PROPOSED CABLE TRAYS FOR THE LHO Y-END STATION – ISOMETRIC VIEW
(showing superposition of equipment positions in support of the cartridge installation of both WBSC6 and WBSC10)

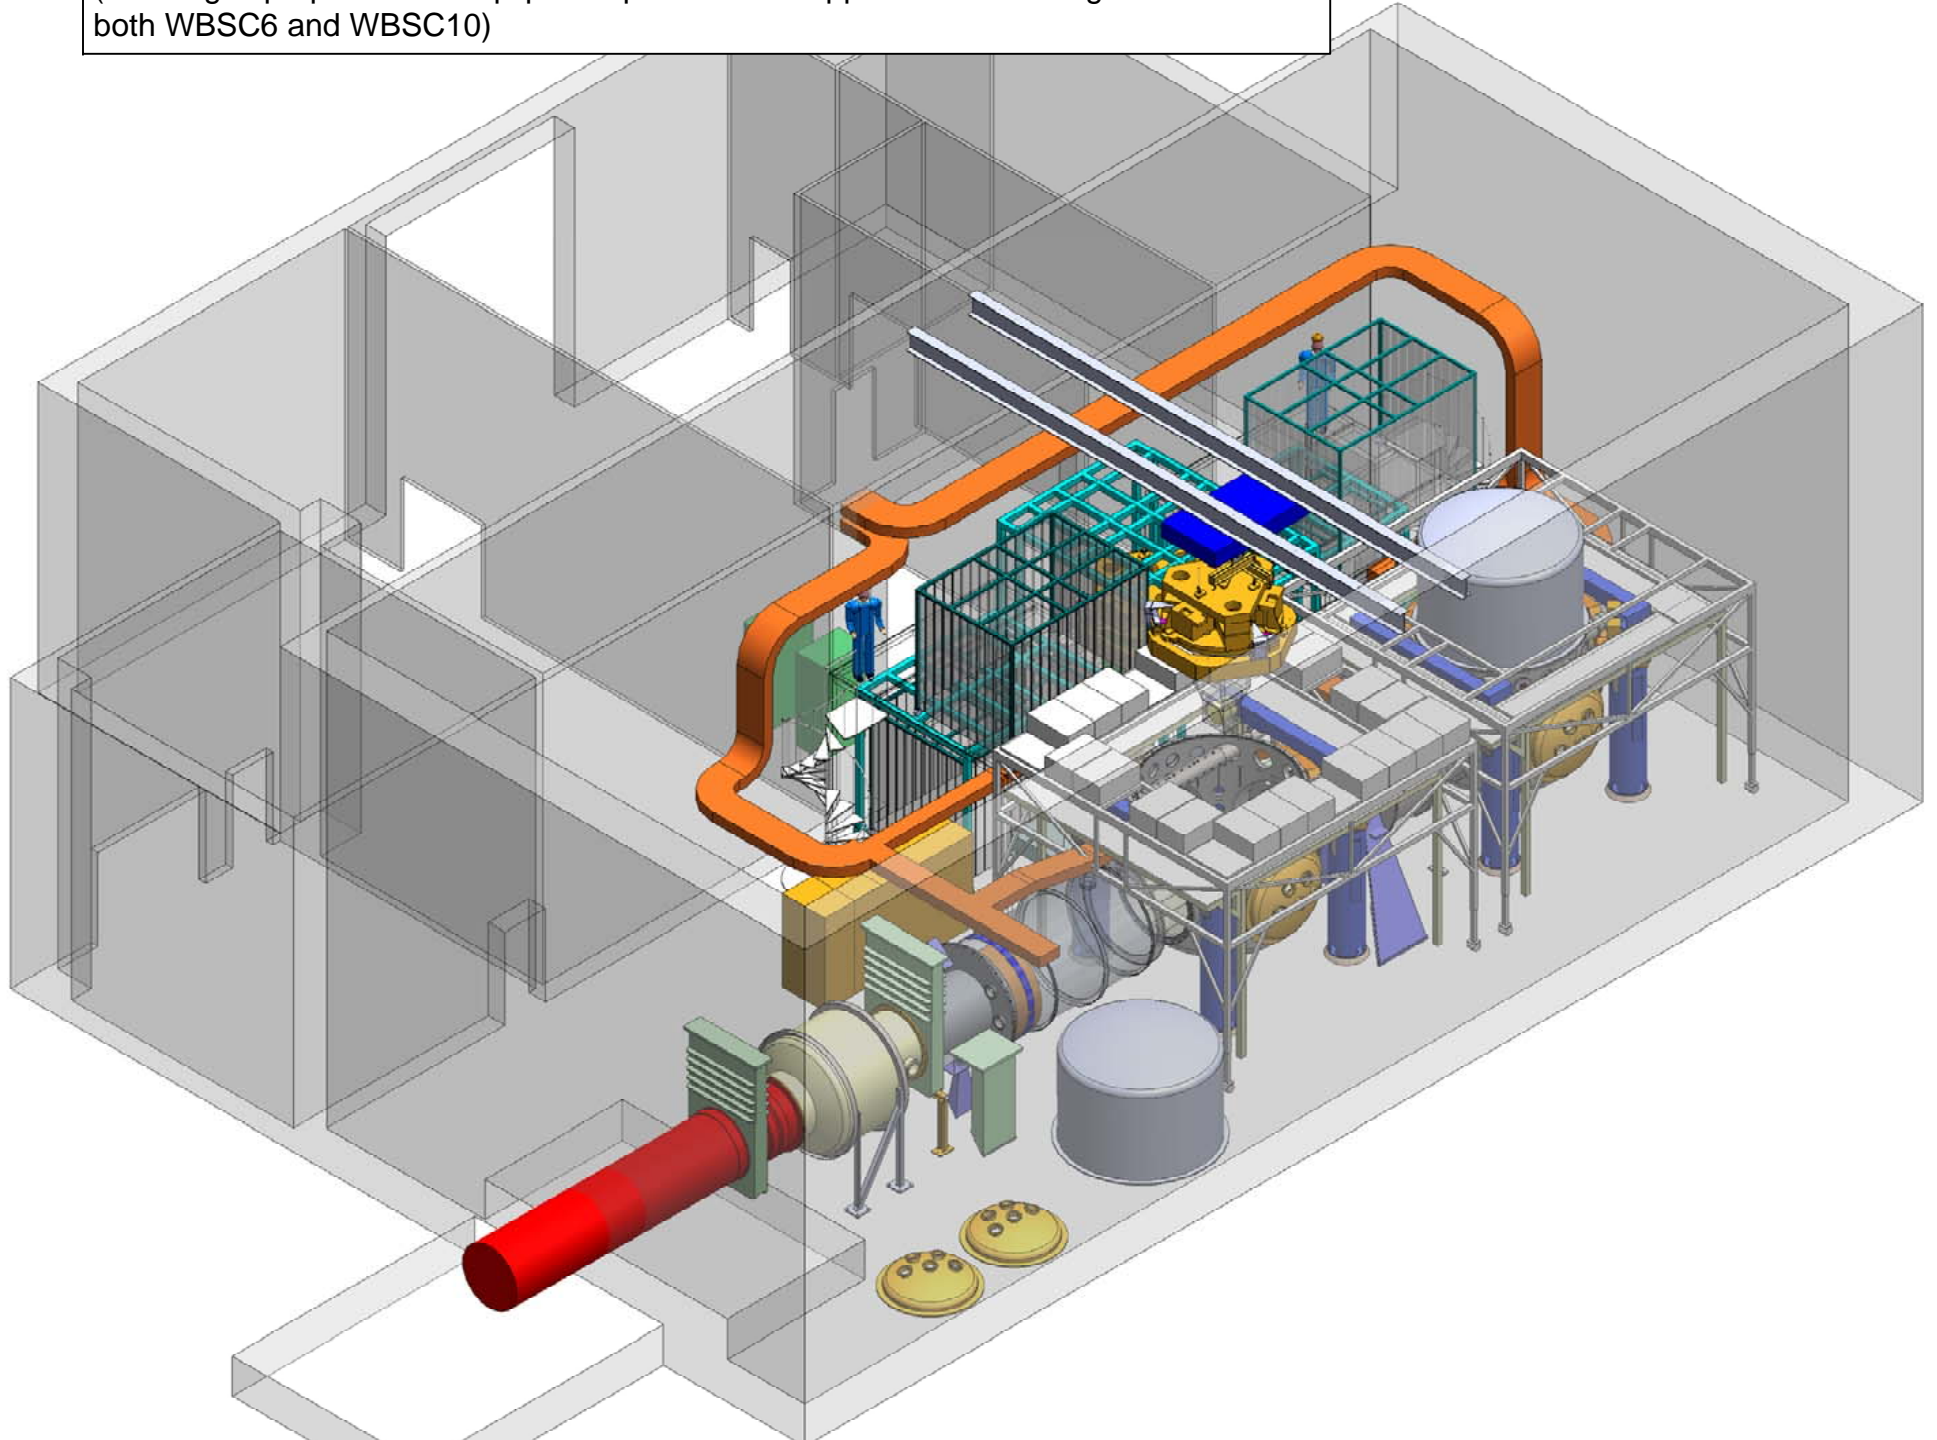
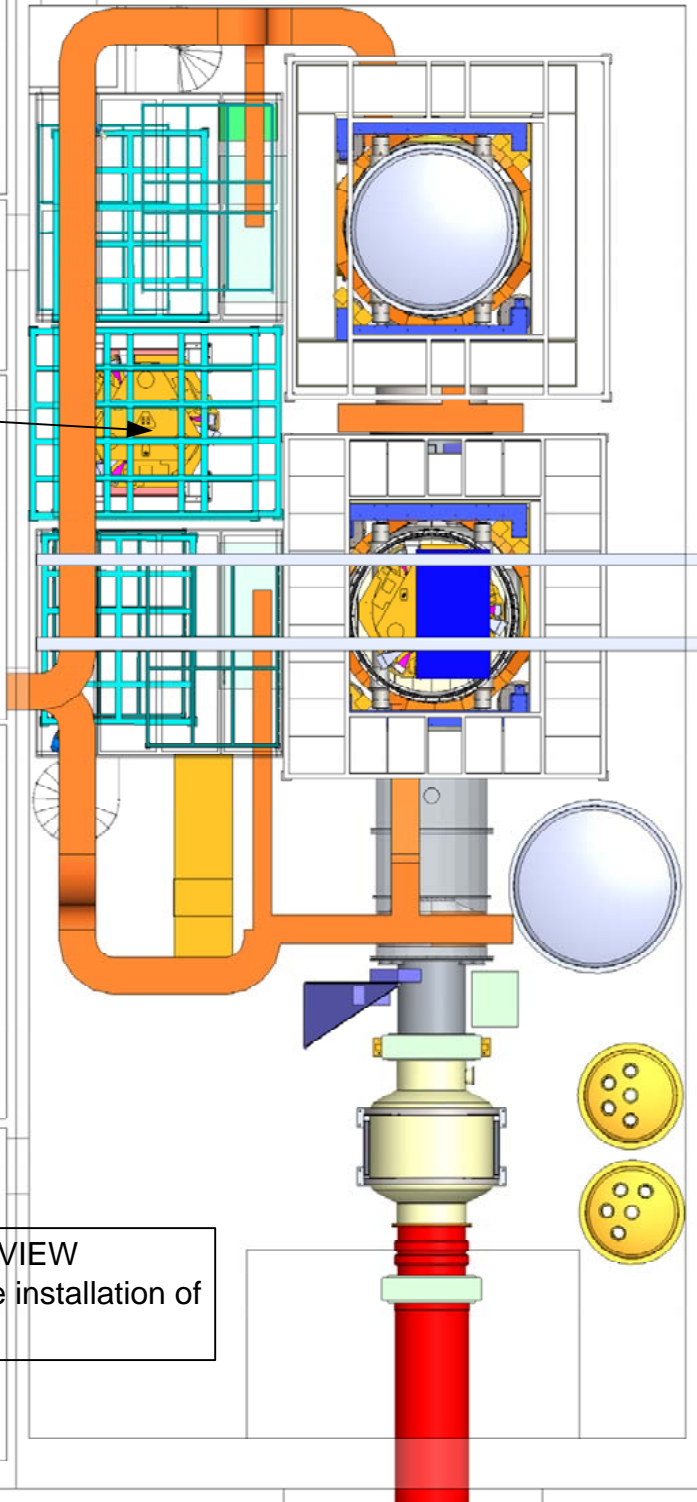
FOR THE FMP INSTALLATION CLEANROOM FINAL DESIGN REVIEW (T1000548-v5), TWO LOCATIONS OF THE SEI-ISI MECHANICAL TEST STAND WERE DEPICTED – ONE FOR CARTRIDGE INSTALLATION INTO WBSC6 AND ANOTHER FOR WBSC10. IT IS BEST IF A SINGLE LOCATION OF THE ISI TEST STAND CAN BE USED (AS SHOWN HERE).

IAS SURVEY EQUIPMENT VIEW OF
ETM HR FACES (THROUGH CLEAN
ROOM CURTAIN WALLS)

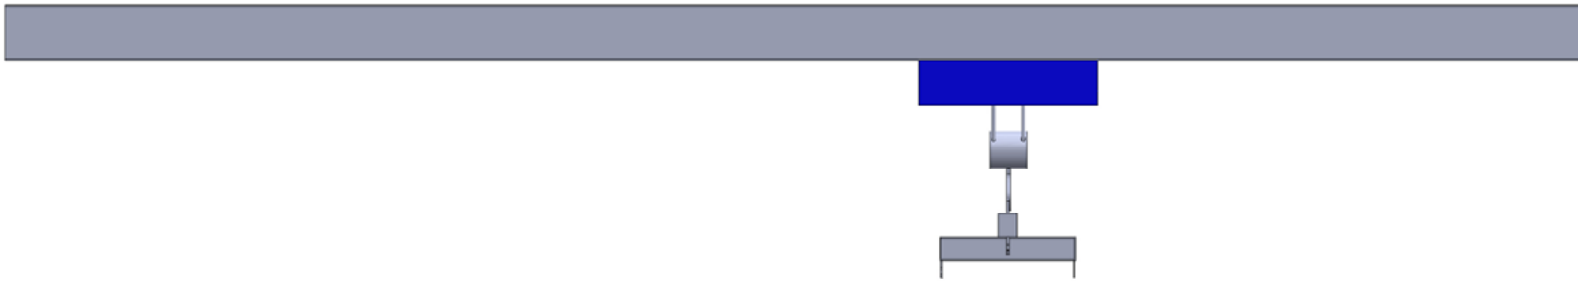
NO CABLE TRAYS IN
PROXIMITY OF HEPI
PIER ASSEMBLIES

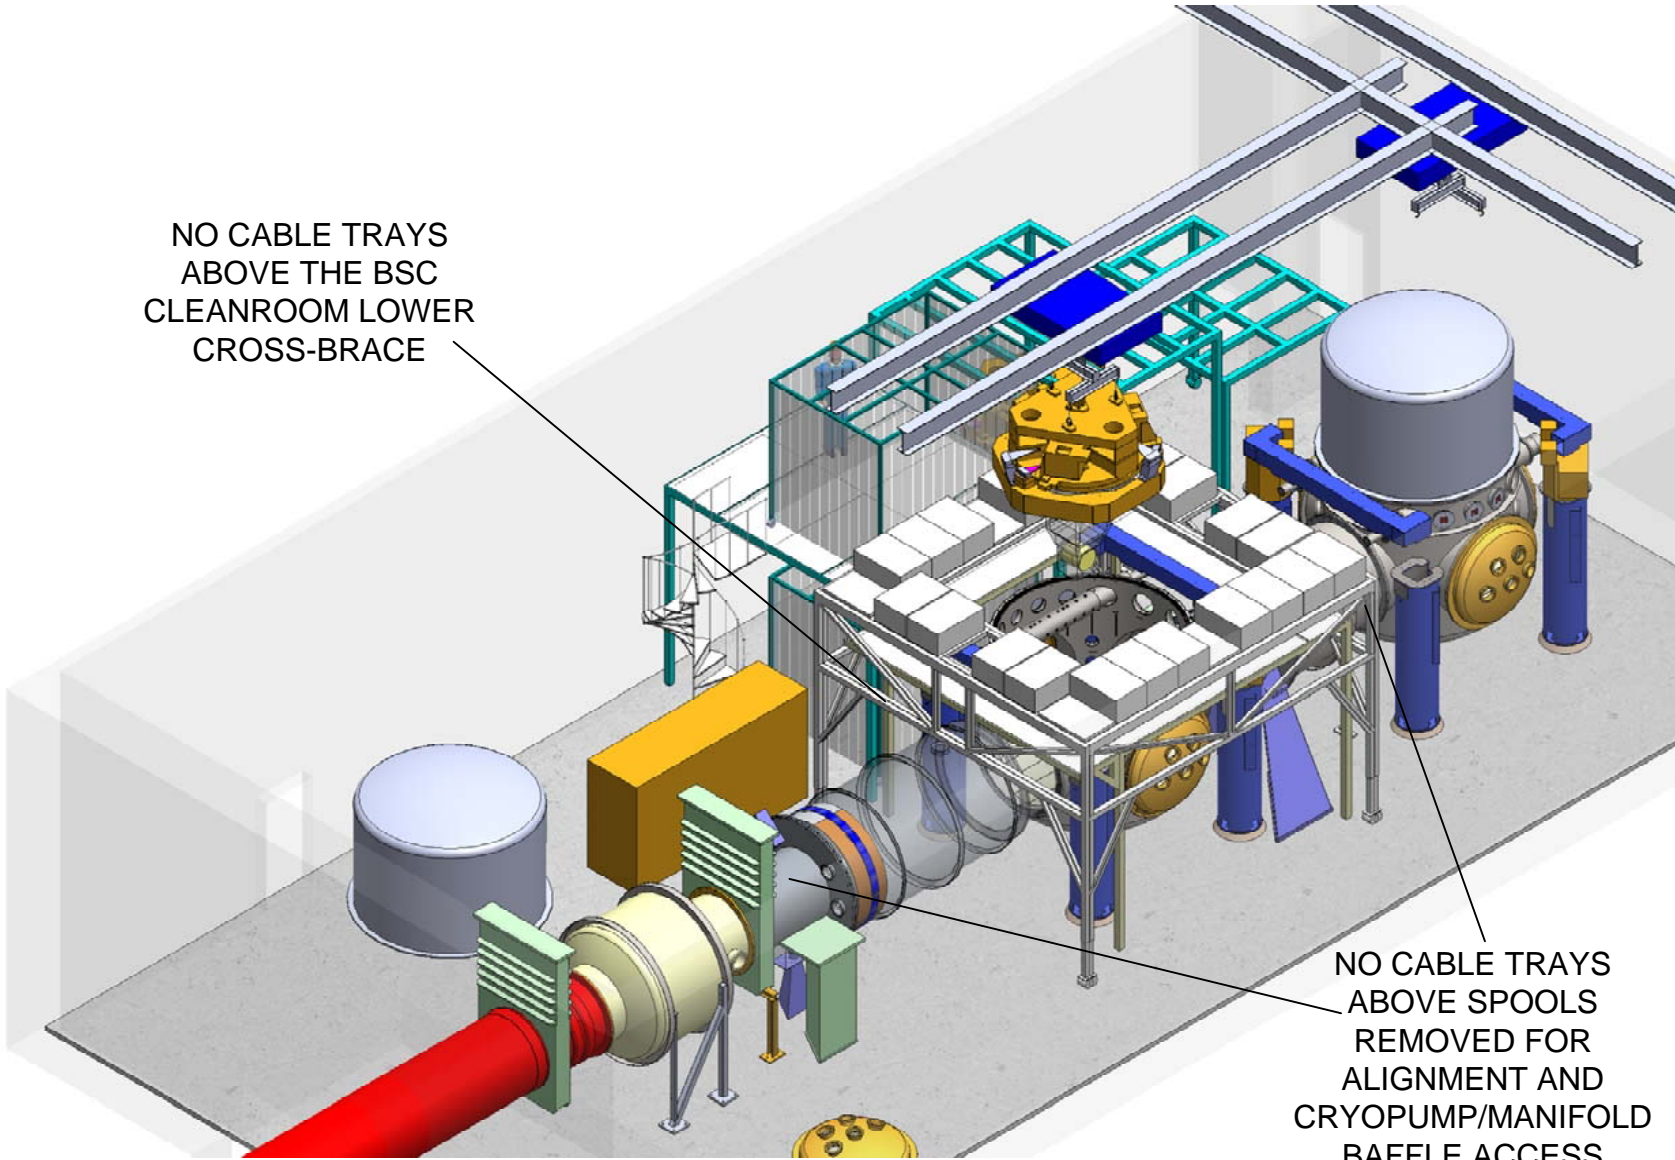
NO CABLE TRAYS
IN PROXIMITY OF
VIEWPORTS

NO CABLE TRAYS
ABOVE THE BSC
CLEANROOM LOWER
CROSS-BRACE

NO CABLE TRAYS
ABOVE SPOOLS
REMOVED FOR
ALIGNMENT AND
CRYOPUMP/MANIFOLD
BAFFLE ACCESS

OPTICAL LEVER
RECEIVER PYLON FOR H2
ETM BLOCKS POSSIBLE
CABLE TRAY ON THIS
SIDE

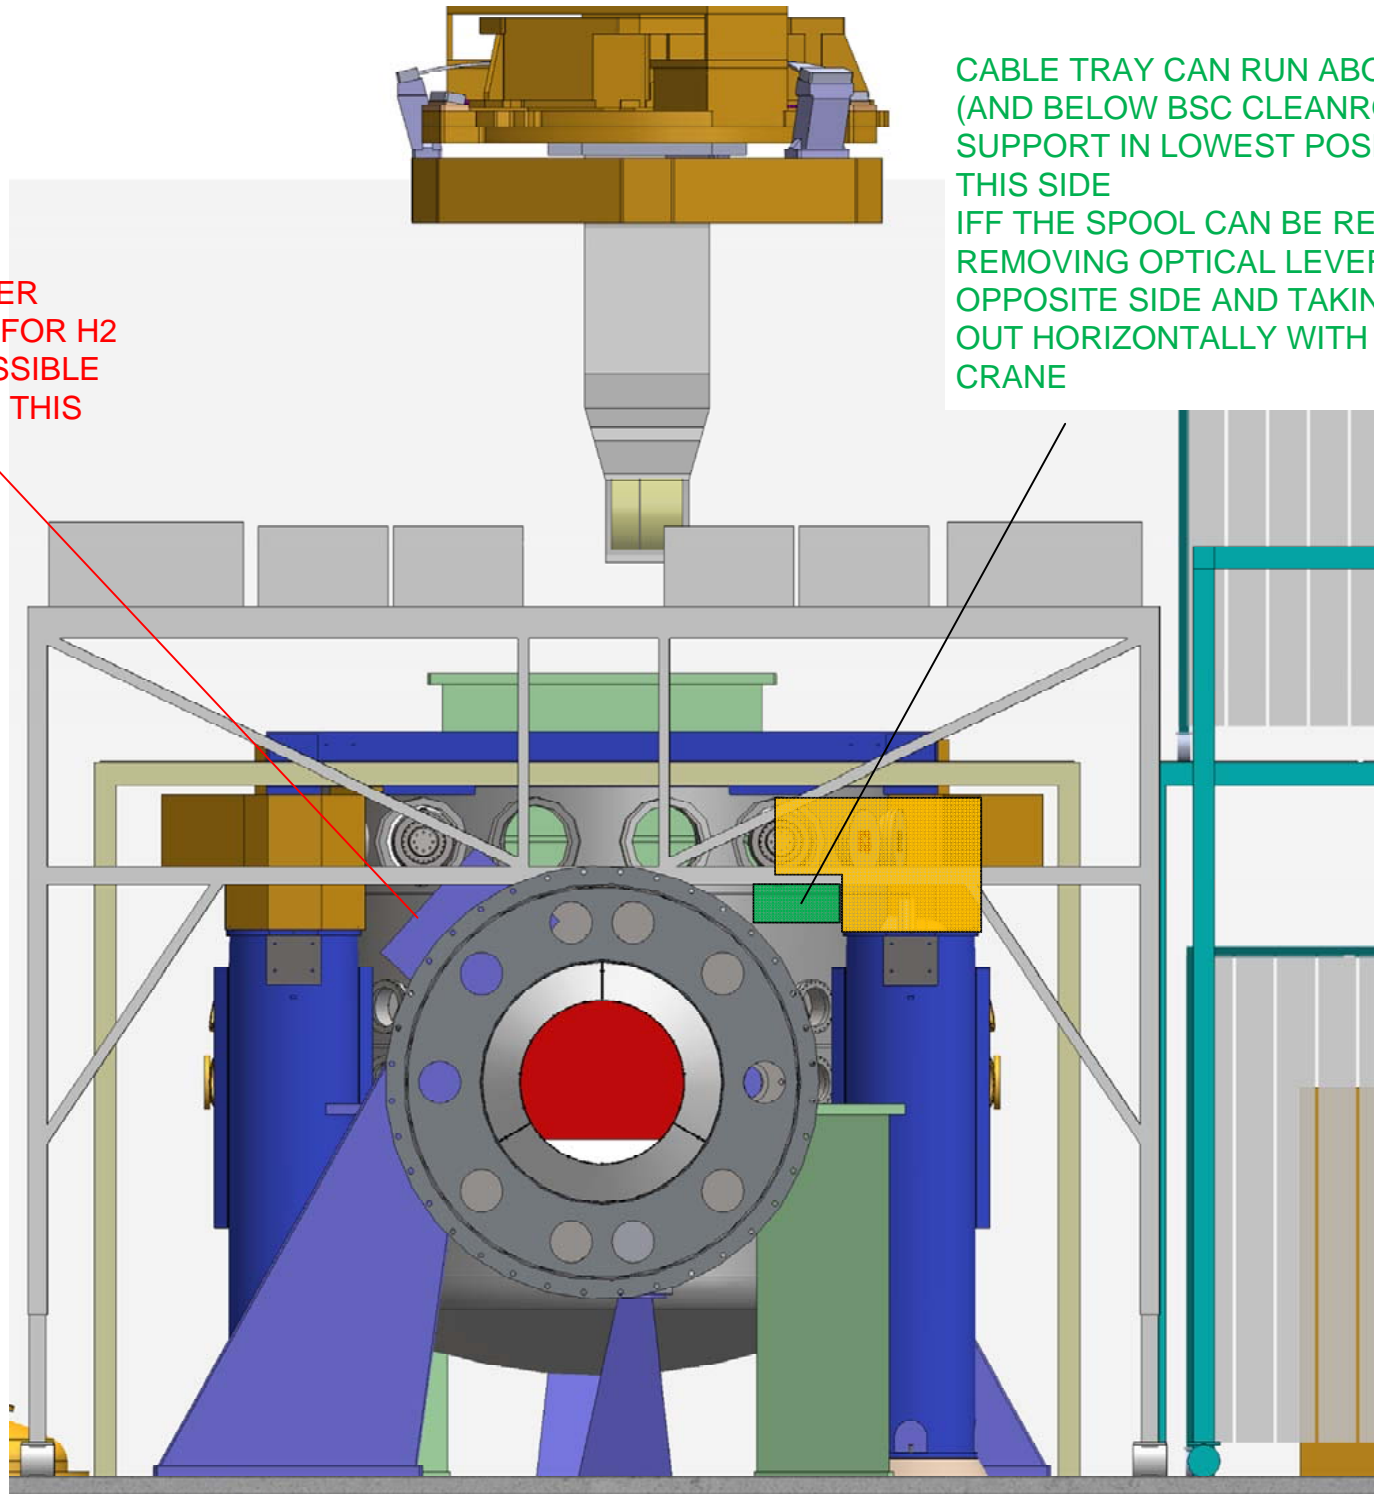
CABLE TRAY CAN RUN ABOVE SPOOL
(AND BELOW BSC CLEANROOM CROSS
SUPPORT IN LOWEST POSITION) ON
THIS SIDE
IFF THE SPOOL CAN BE REMOVED BY
REMOVING OPTICAL LEVER PYLON ON
OPPOSITE SIDE AND TAKING SPOOL
OUT HORIZONTALLY WITH OVERHEAD
CRANE

REGIONS WHERE A CABLE TRAY CAN PASS FROM THE VEA INTERIOR WALL TO THE BEAM LINE AREA ARE SHOWN IN YELLOW

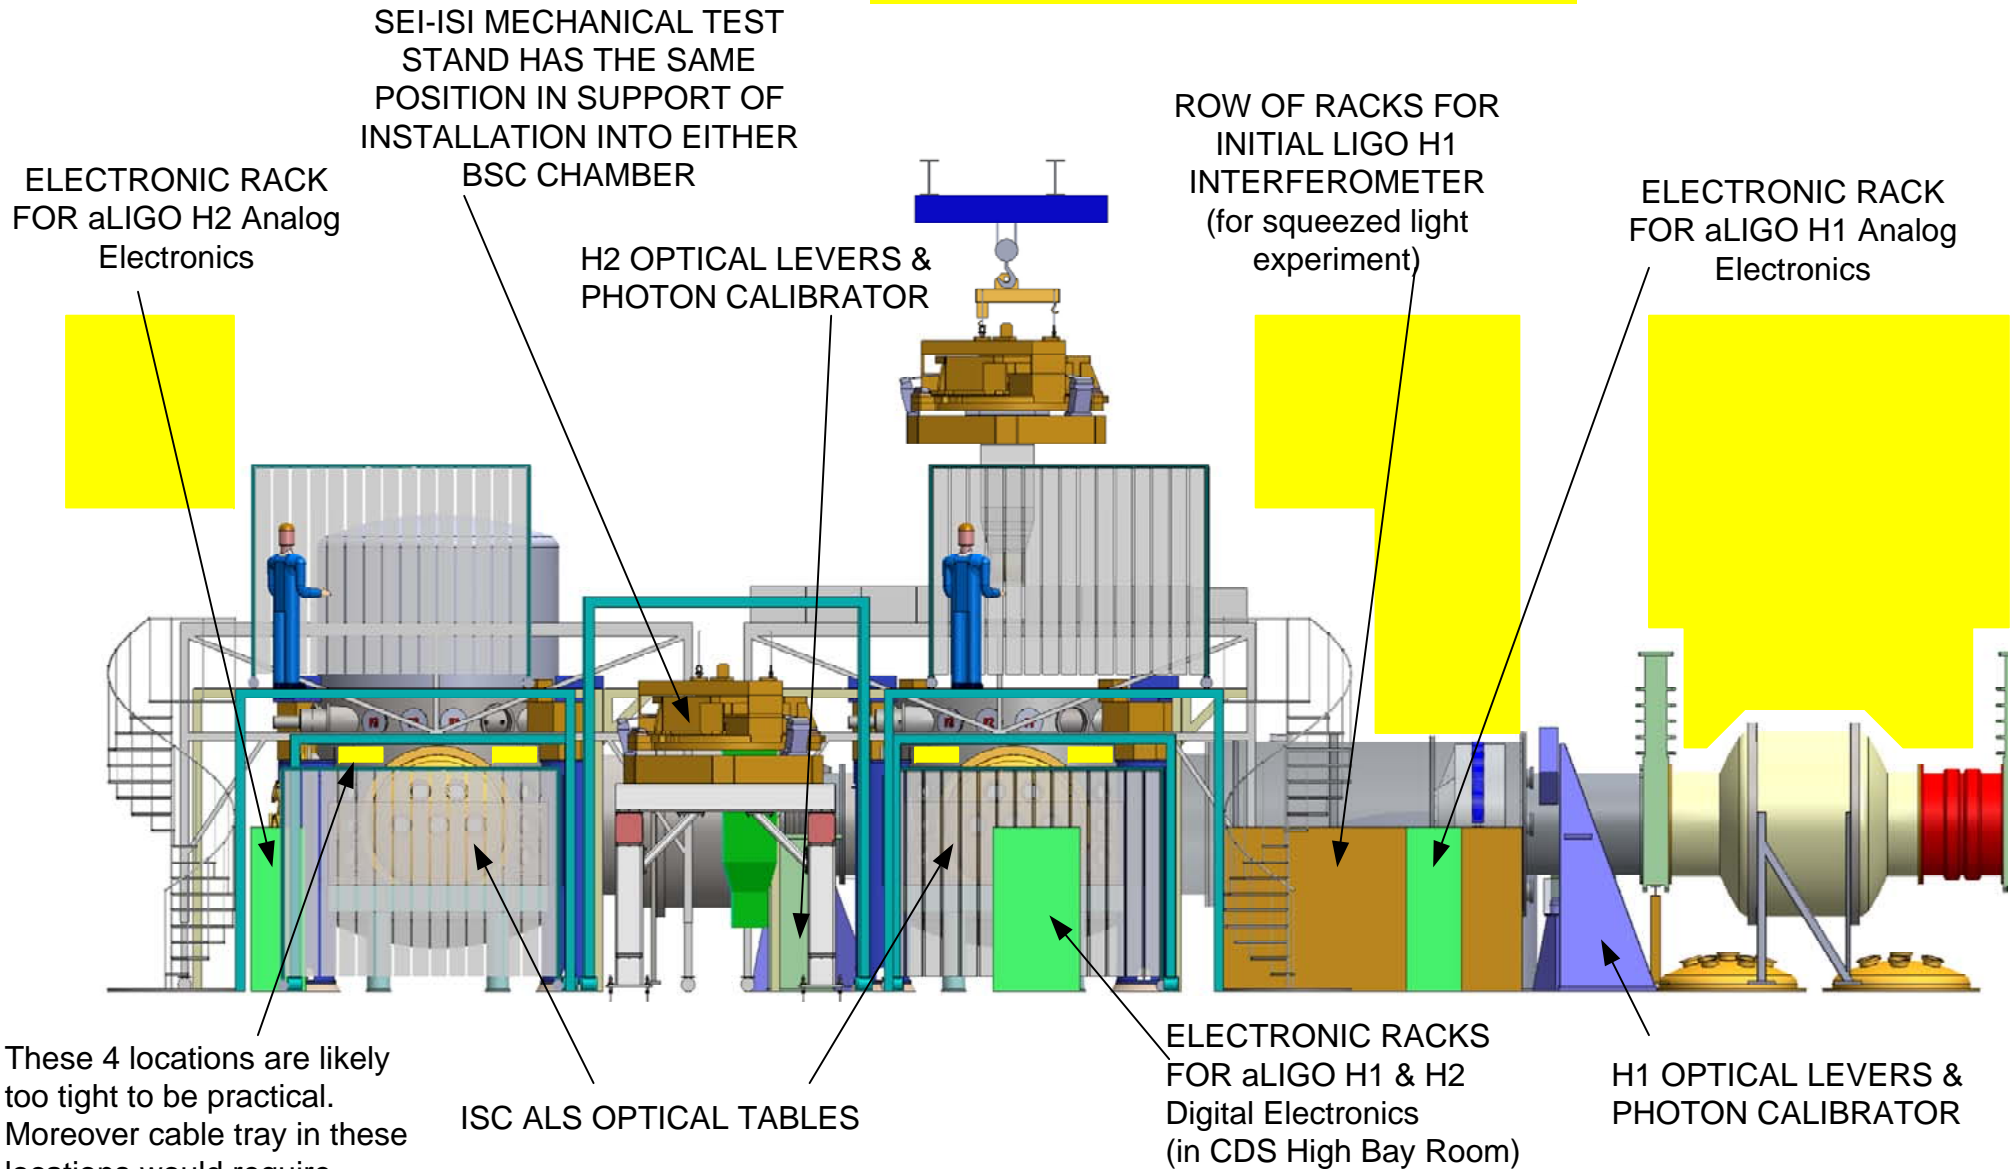
These 4 locations are likely too tight to be practical. Moreover cable tray in these locations would require craning the smaller cleanrooms.
